**Subject: Overlook at Centennial & Fillmore, PUD Zone Change & Concept Plan;
Colorado Springs, El Paso County, CO;
City Nos, CPC MPA 04-000430-A6MJ20, CPC PUZ 20-00119,
CPC PUP 20-00120; CGS Unique No. EP-21-0016 2**

The Colorado Geological Survey (CGS) has reviewed the resubmittal. New documents included: PUD Concept Plan (10.16.20), Response to CGS Comments (CTL | Thompson, 10.6.20), Initial Review Letter (NES Inc., 10.6.20), and a Zone Change Drawing (10.16.20). We previously reviewed this submittal in our letter dated September 10, 2020, and while our concerns have largely been addressed, we offer the following comments for your consideration:

Fig. 1. Location of the fill areas at the Overlook at Centennial & Fillmore site (CPC PUP-20-00120; CTL | T Project No. CS19060-145).

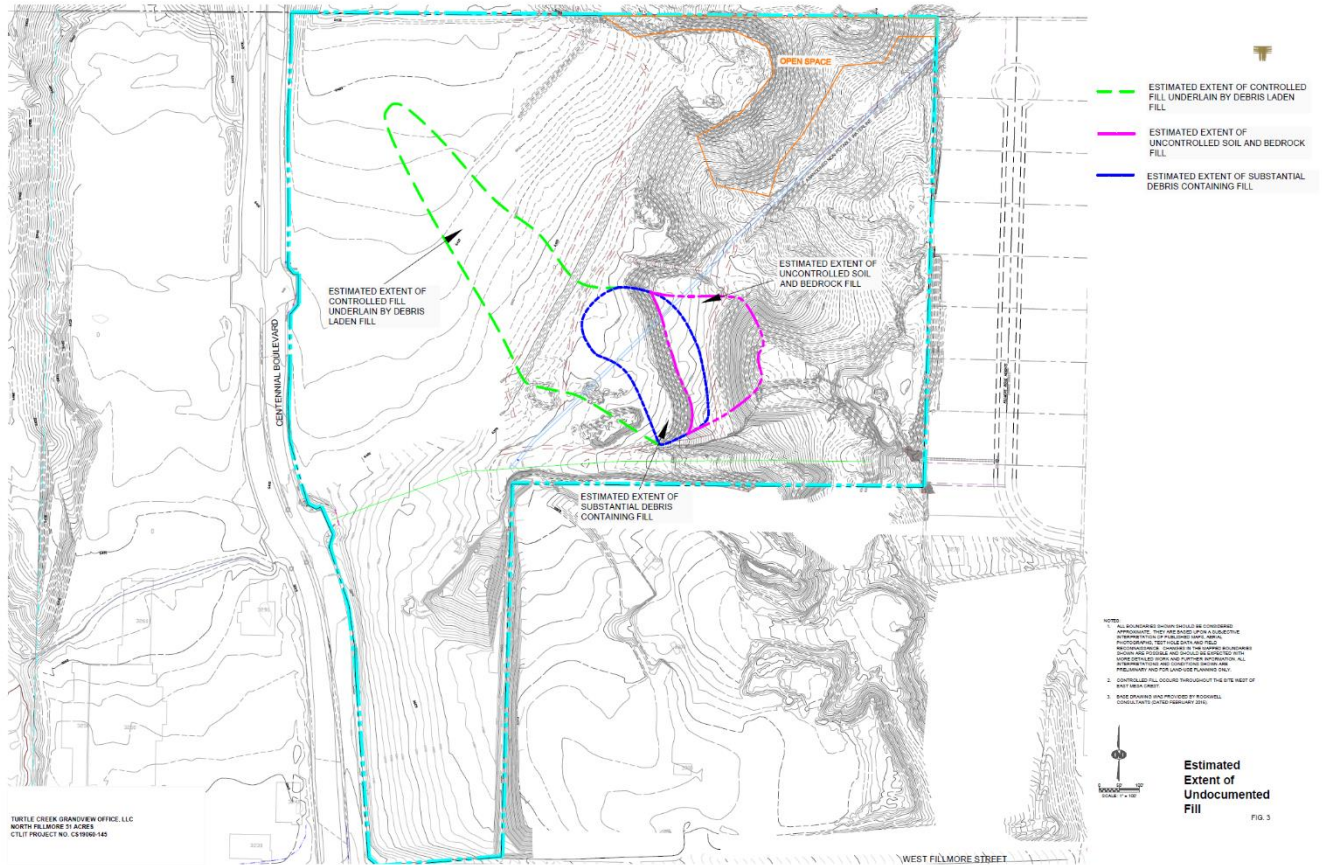
CTL | Thompson Response to Colorado Geological Survey Comments. CTL | Thompson provided a response to our initial review letter (CGS EP-21-0016, 9.10.20) with this submittal, addressing our comments. We erroneously described the content of the fill areas in our initial letter (Fig. 1, this report) – per CTL | Thompson, trash, lumber, and organic debris are limited to the blue outlined area described on Fig. 1 (Fig. 3, CTL | Thompson Geotechnical Report, No. CS19060-145) as the ‘estimated extent of the substantial debris containing fill’. Trash, lumber, and organic debris are not present in the green outlined area of Fig. 1 (Fig. 3, CTL | Thompson Geotechnical Report, No. CS19060-145) described as the ‘estimated extent of controlled fill underlain by debris laden fill’. In their response letter (10.6.20), in regards to the green outlined area of controlled fill, CTL | Thompson states ‘...during site grading in the early 1980’s, the direction was to remove any questionable materials in the drainages to at least 20 feet below the proposed (now existing) grades. This depth of cover should only be less than 20 feet if future cuts are made in this area. If that is the case, the geotechnical engineer associated with land development should evaluate the increase in risk of damage due to consolidation. The geotechnical engineer associated with structure design and construction should also judge the influence of the undocumented fill below the controlled fill’. Should cuts occur on site, provided that these guidelines are followed, **CGS has no objection to approval of the zone change and concept plan.**
